**PERMIT MODIFICATION FOR
ASPHALT SHINGLES RECYCLING**

**COBLE'S SANDROCK, INC. C&D LANDFILL
PERMIT NO. 01-05**

RE: **Coble's Sandrock, Inc. C&D Landfill
Application review – Asphalt Shingles Recycling
Response to Comments, Doc. ID No. 13312
JEI PROJECT NO. 419.1101.12, Task 02**

DRAWING NO.
1

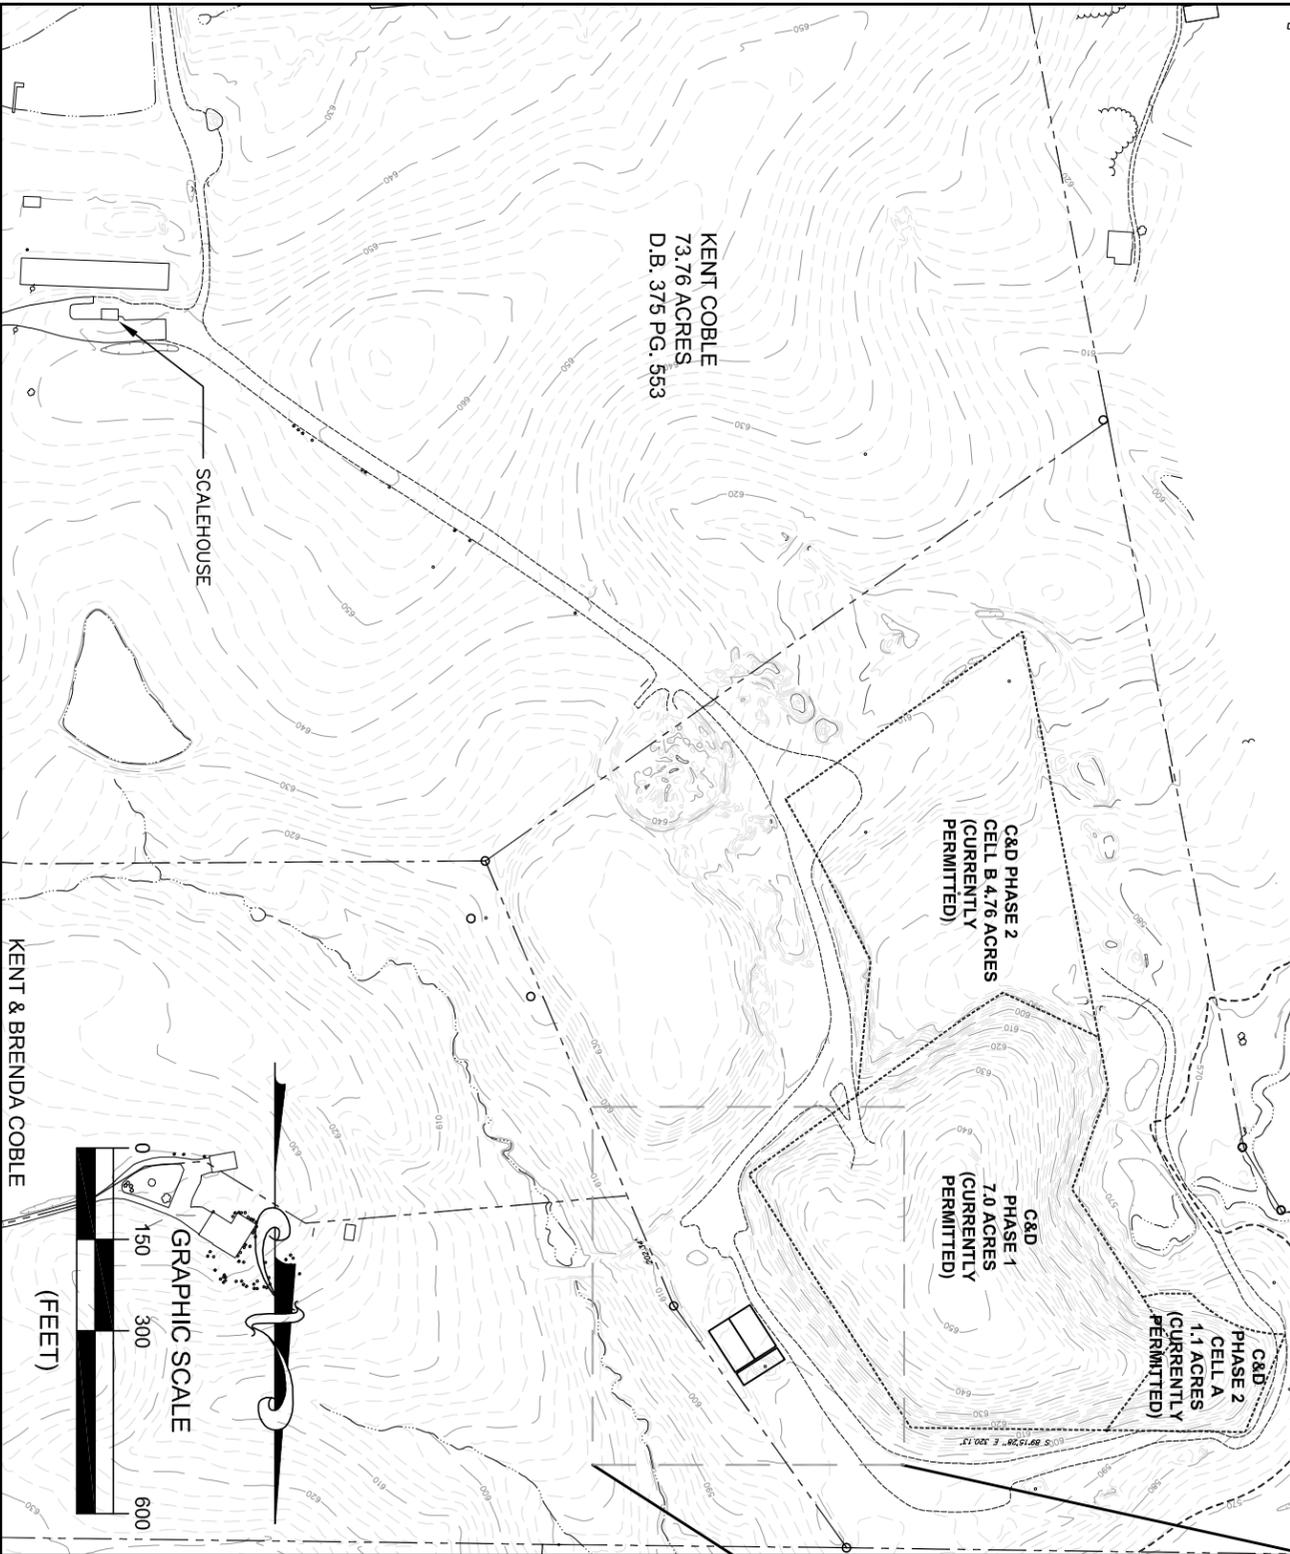
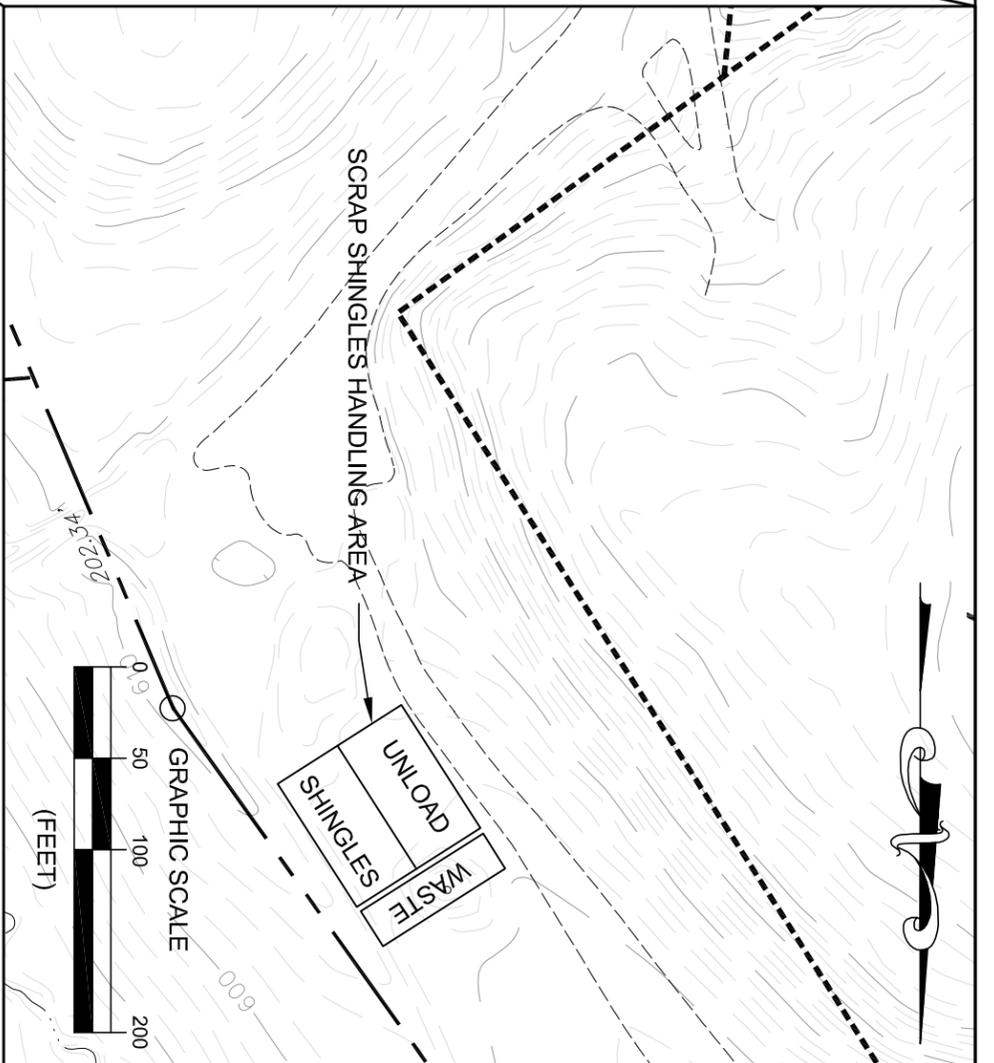
4. Please provide a drawing for the shingles area. Indicate the areas for unload, sorting, and storage. Also indicate how the areas will be designated. For example, some facilities are using signs to designate locations and "Jersey" barriers to allow flexibility on separating piles. Please also insure that it is not encroaching on the LCID limits. I cannot determine that from the drawing submitted.

The drawing has been revised to address requested comments. Jersey barriers will be placed around the work areas. The RAS area has been relocated away from the LCID. The new location is adjacent to the access road to Phase 3A.
